"CRC" 45MM-400 CAP

DRAWING REVISION PAGE

SUBJECT: CRC-45-400 CAP ASSEMBLED

DOC: C-8020

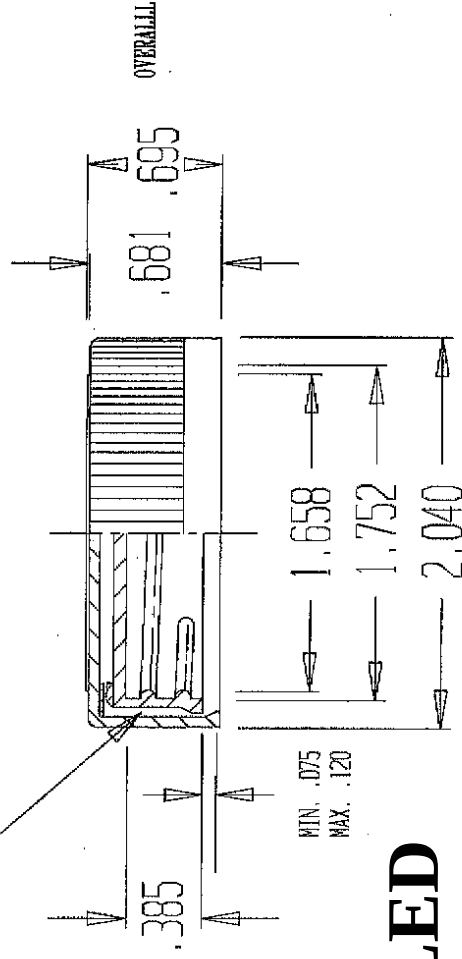
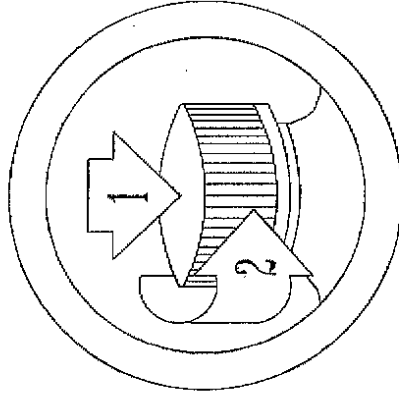
REV LEVEL	REV DATE	DESCRIPTION OF CHANGE
1	Jun. 28, 2004	Historical data indicates closure H dimension has never reflected actual dimension. Drawing updated. H=.385. No tooling change.
